ZONING CHANGE REVIEW SHEET

CASE: C814-2007-0009.01 **P.C. DATE:** May 13, 2014
The Terrace in Oak Hill Planned Unit Development
(formerly West 71 Office Park Planned Unit Development)

SUBJECT: Terrace in Oak Hill (Formerly called West 71 Office Park)
Planned Unit Development Ordinance Number 20070726-104

EXHIBIT B

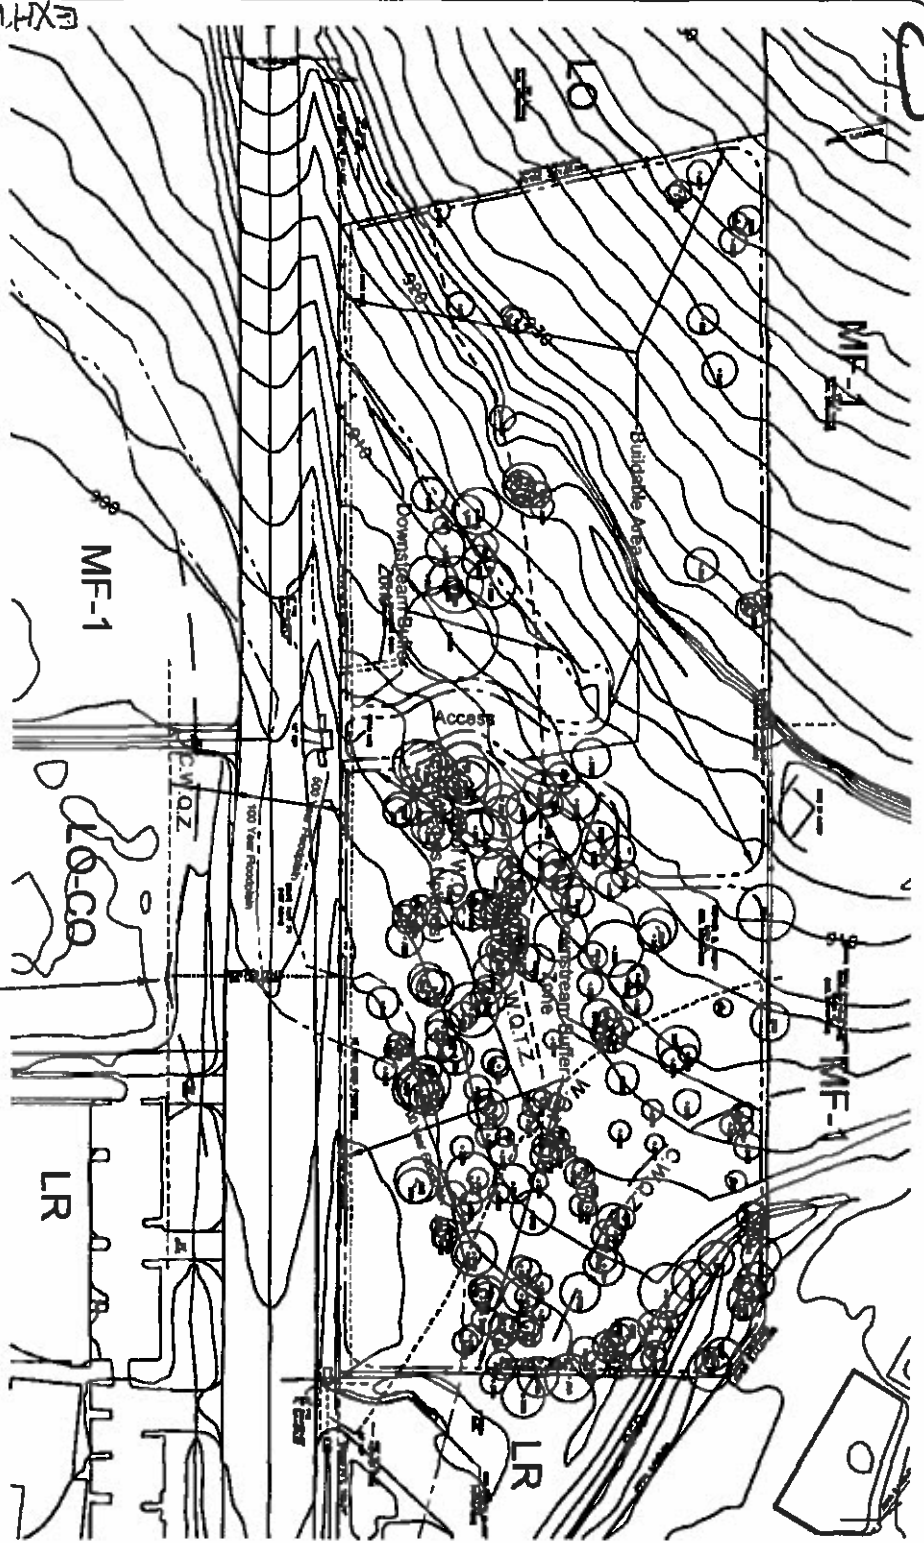
2. Ordinance Number 20070726-104, Part 4.B: "Section 25-8-483 (*Water Quality Transition Zone*) is modified to allow a 3.34 acre portion of the Property associated with Williamson Creek and identified on the Land Use Plan to be classified as Uplands Zone."

Based on a review of current City of Austin GIS data, the minor waterway located at the northeast corner of the property has a 50 foot wide Critical Water Quality Zone and a 100 foot wide Water Quality Transition Zone. However, the approved 2007 Land Use Plan (Exhibits B-1 through B-10) shows the Critical Water Quality Transition Zone and the Water Quality Transition Zone to each have a 100 foot width. These boundaries as shown on the approved 2007 Land Use Plan do not coincide with current City of Austin GIS data.

Therefore, the applicant proposes to revise the Critical Water Quality Zone and Water Quality Transition Zone of the unnamed waterway located at the northeast corner of the property (Exhibit D-2 WQTZ Reclassified and Exhibit D-3 CWQZ Reclassified) to reflect current GIS data. This revision will not alter the language of the approved PUD Ordinance; but will require a revision of Land Use Plan associated with the PUD Ordinance (Exhibit C-1 Proposed Land Use Plan and Exhibit C-2 Proposed Land Use Notes).
